MONITORING YEAR 1 ANNUAL REPORT

LONE HICKORY MITIGATION SITE

RE: Lone Hickory Mitigation Site – Monitoring Year 1 Report Final
Yadkin River Basin – CU# 03040101 – Yadkin County
DMS Project ID No. 97135
Contract # 006897

Wildlands Engineering, Inc. (Wildlands) has reviewed the Division of Mitigation Services (DMS) comments from the Draft Monitoring Year (MY) 1 report for the Lone Hickory Mitigation Site. Wildlands' responses to DMS' report comments are noted below in *italics*.

Recorded In-stream Flow Events

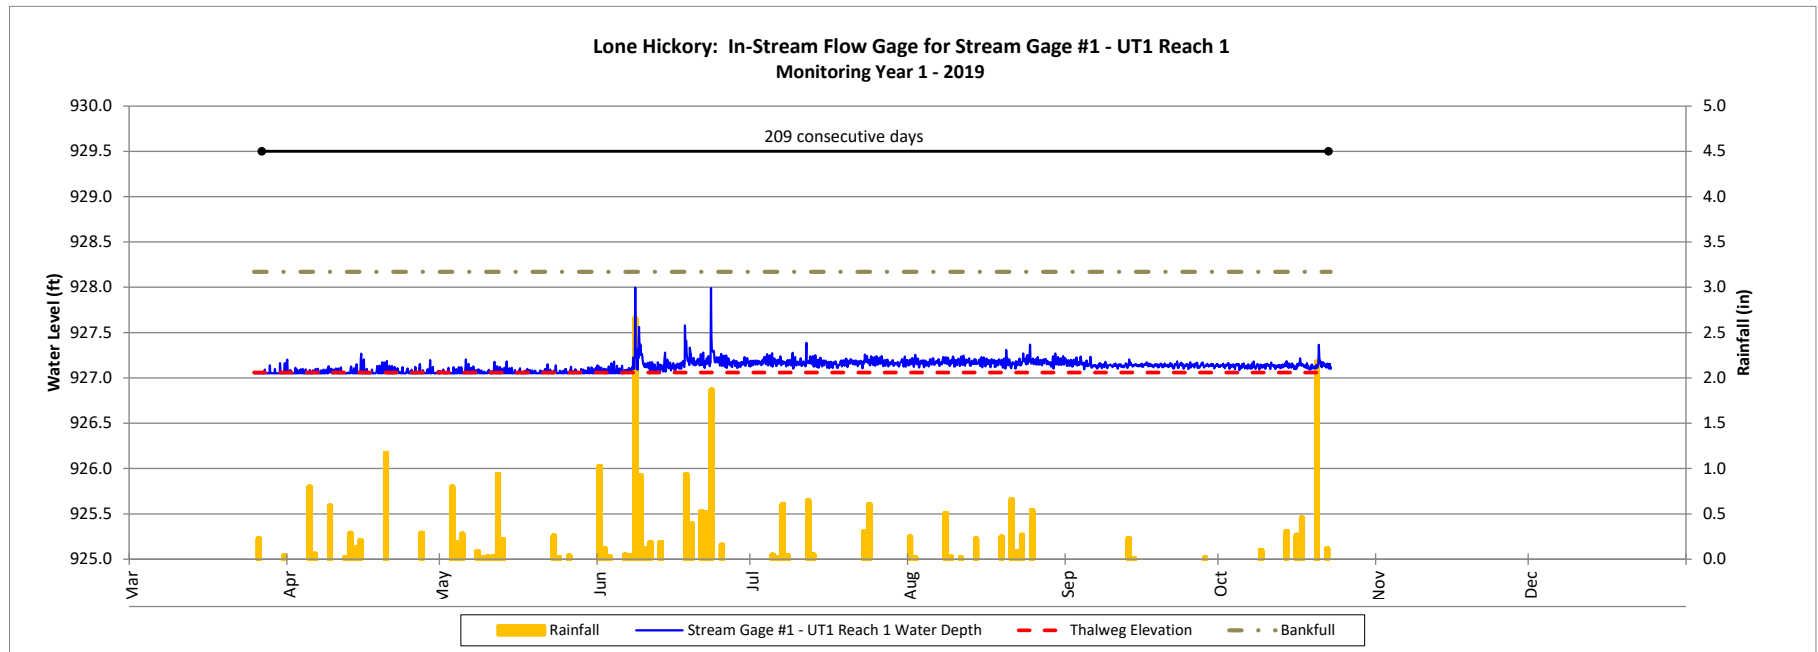
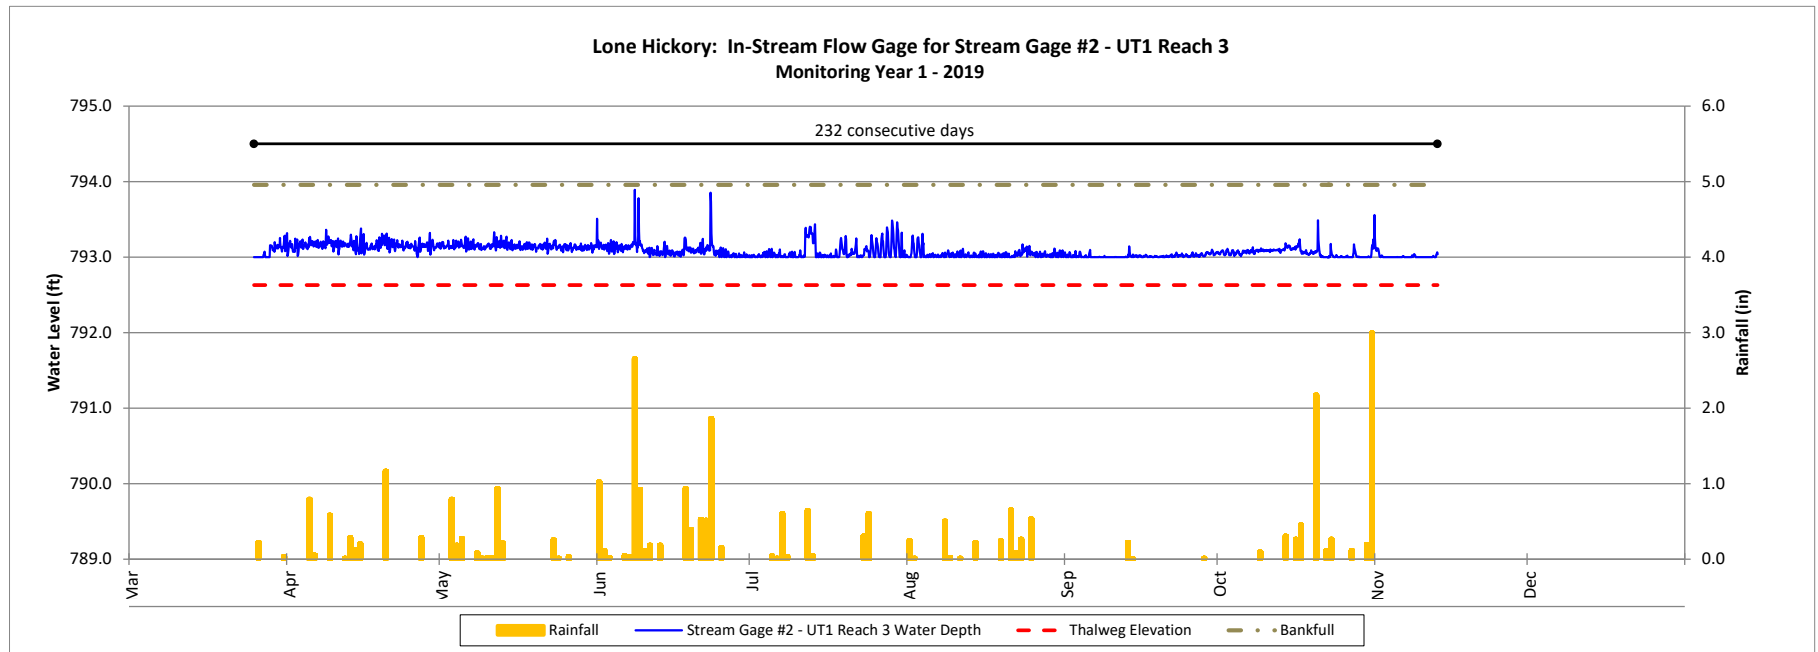
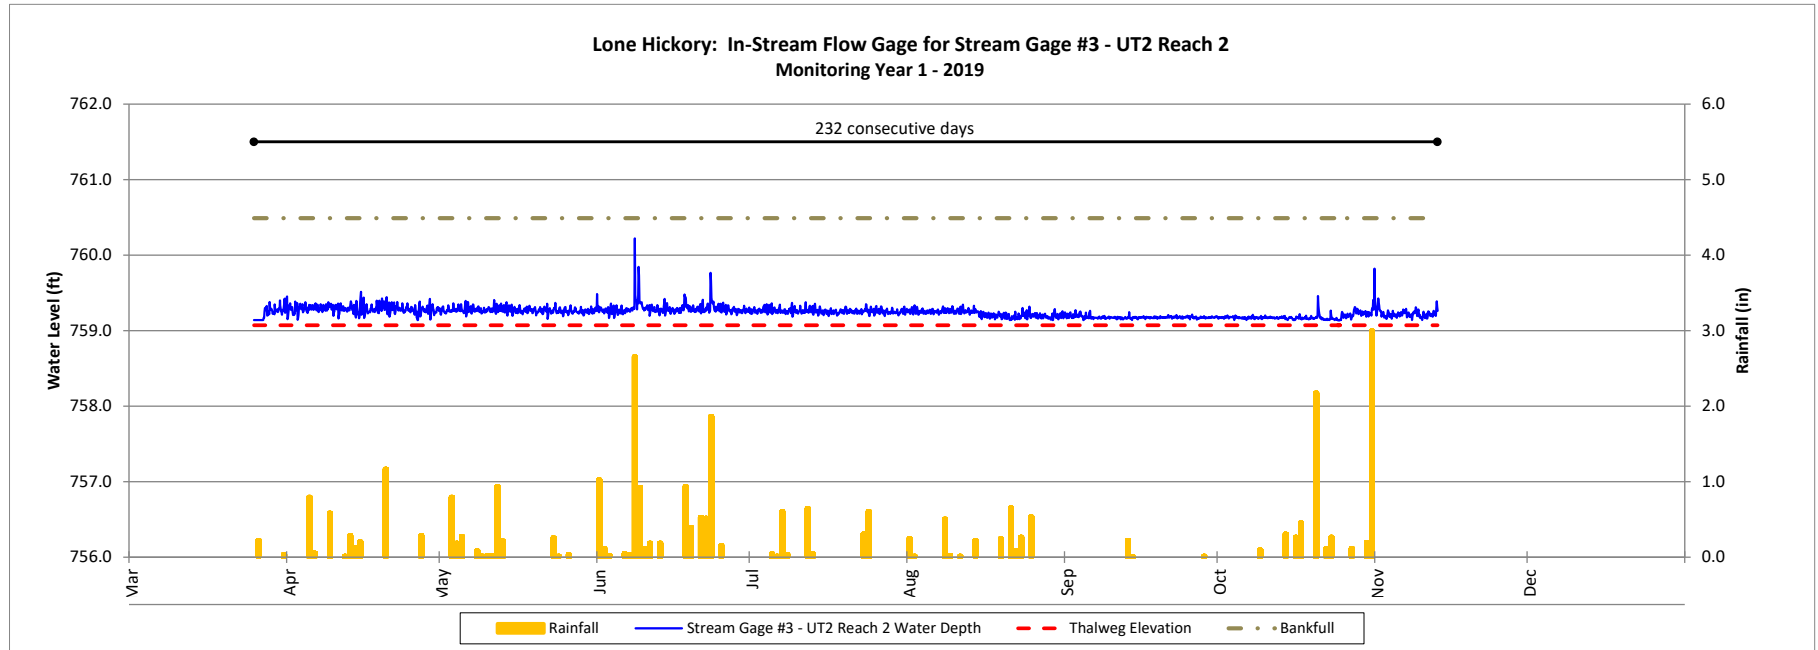
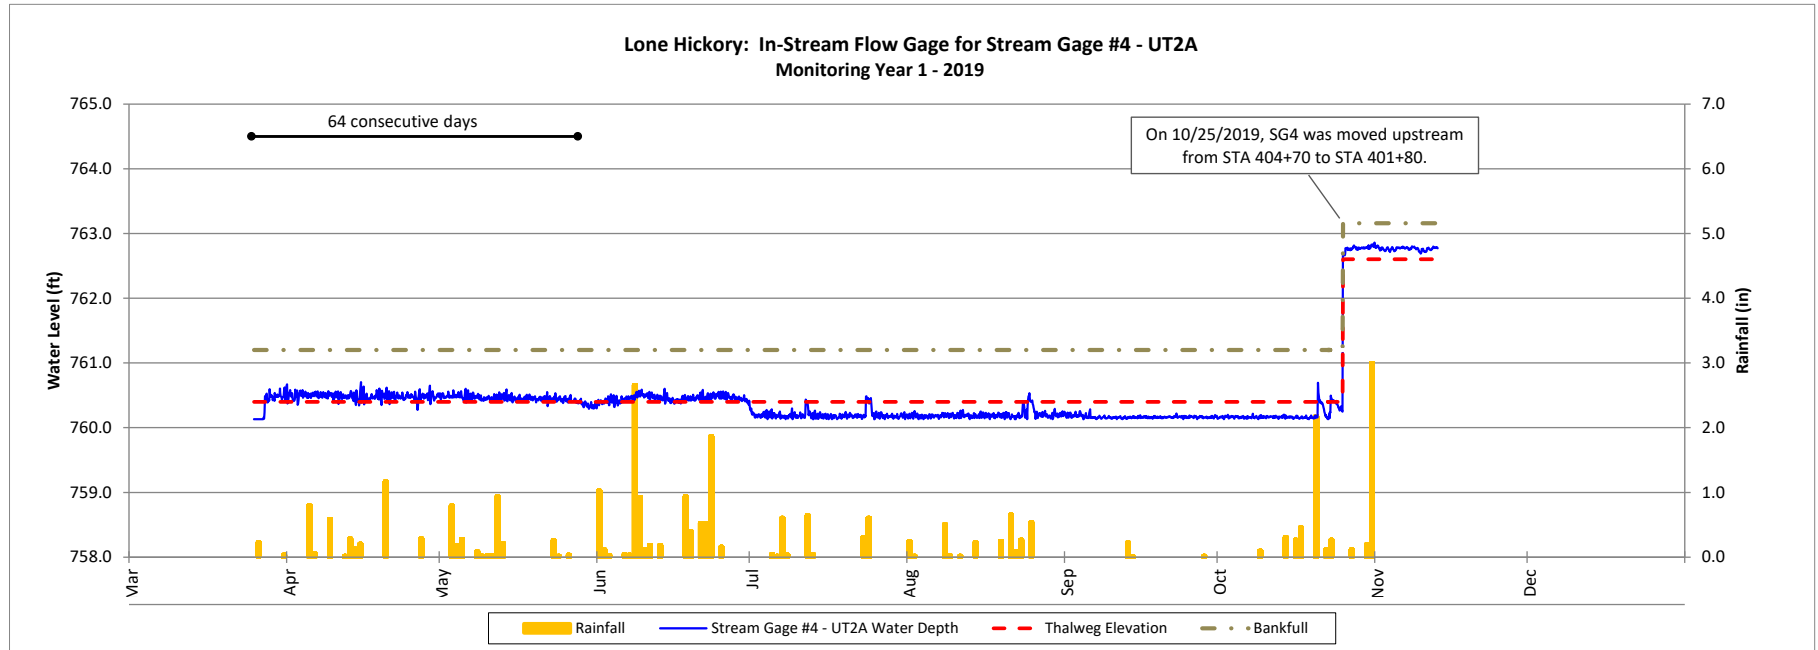
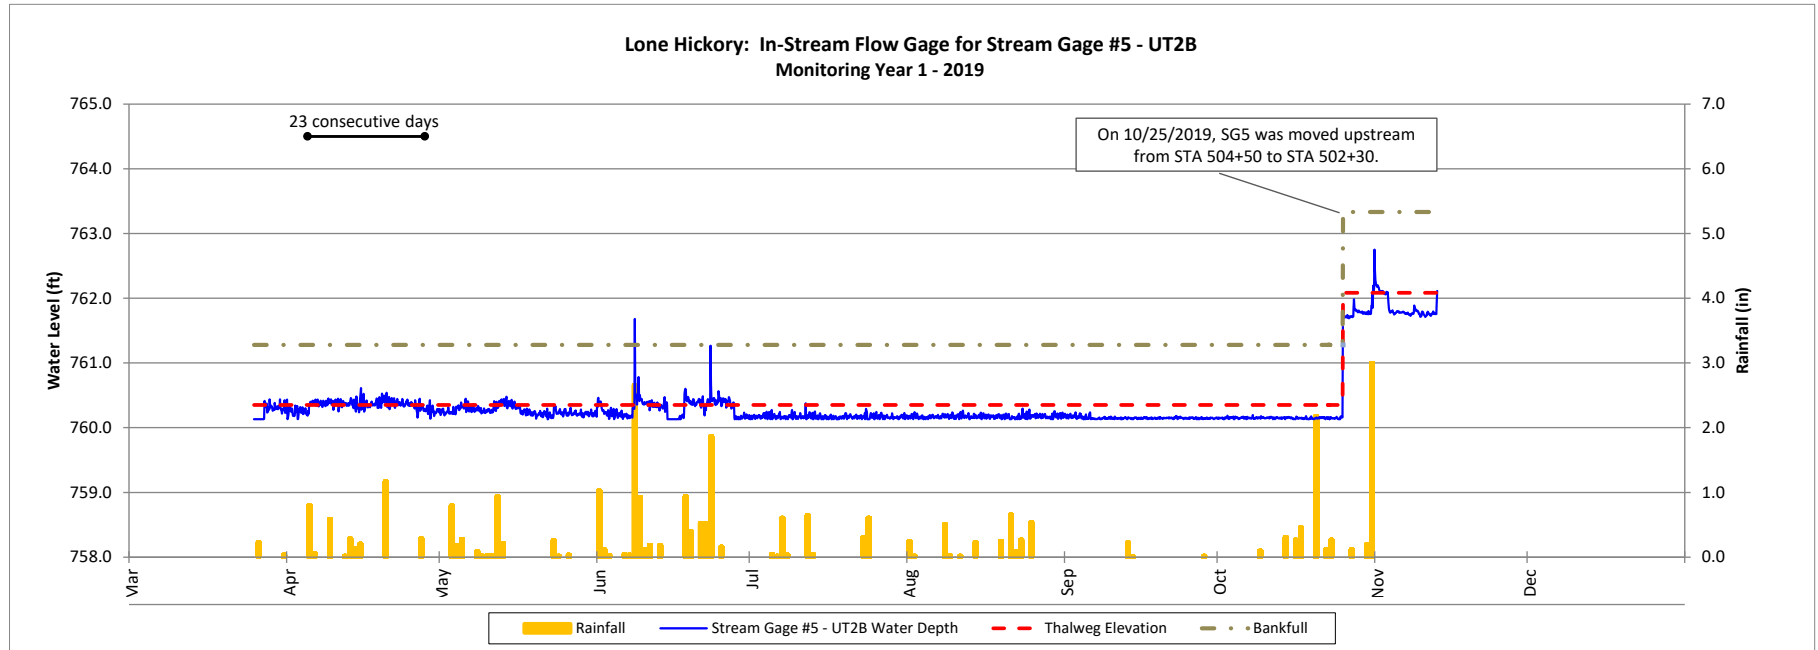
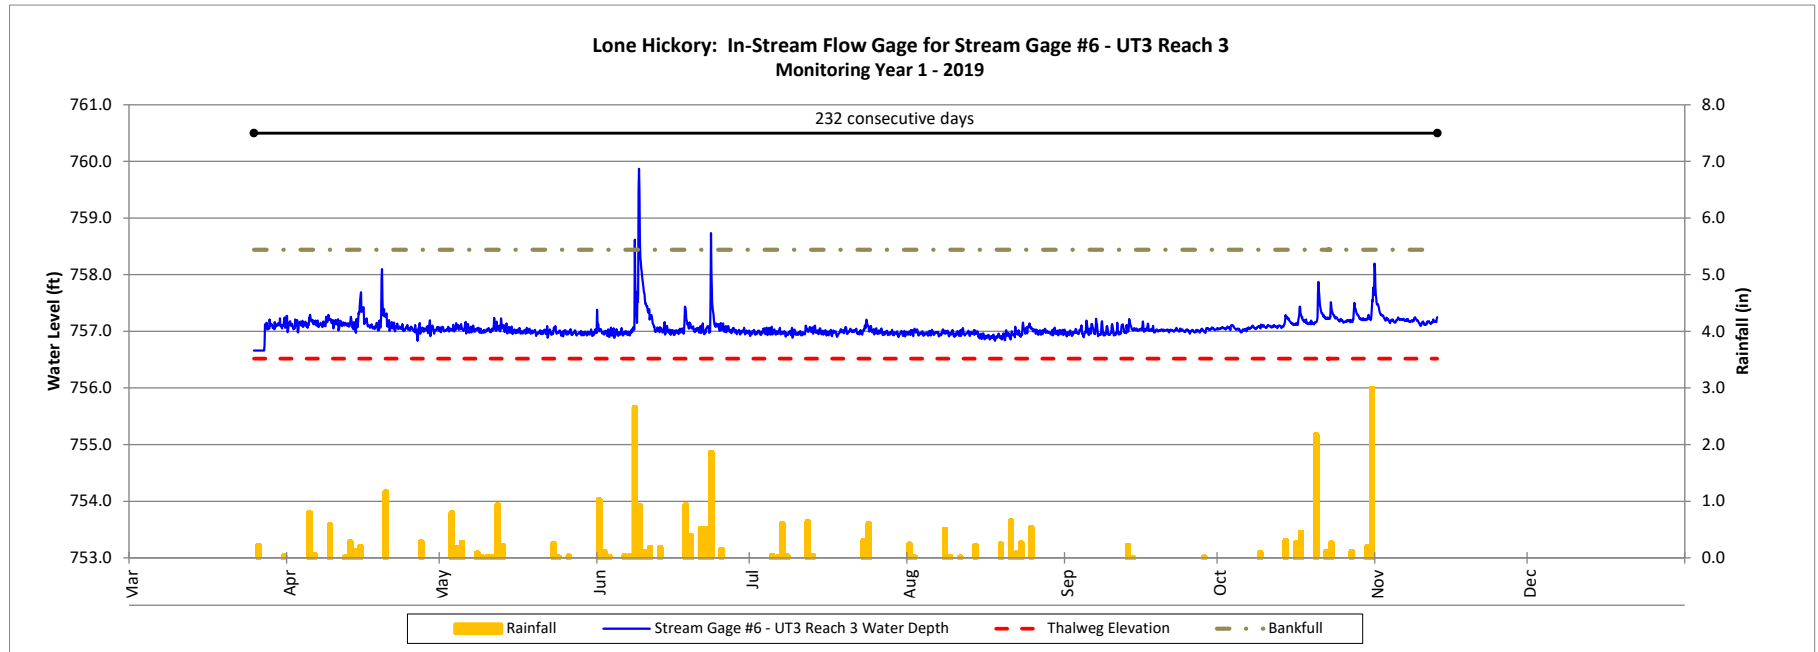
DMS comment; In-Stream flow gage plots: For clarity, consider reporting the maximum consecutive days achieved for each gage on the individual graph. It would also be helpful to show a start and end line that corresponds with the consecutive days reported. Note that gage #1 has a “30 days” line but the other graphs do not. All gage graphs should be consistent in format.

Wildlands response; For clarity, the maximum number of consecutive days achieved by each gage has been added to all stream gage plots.
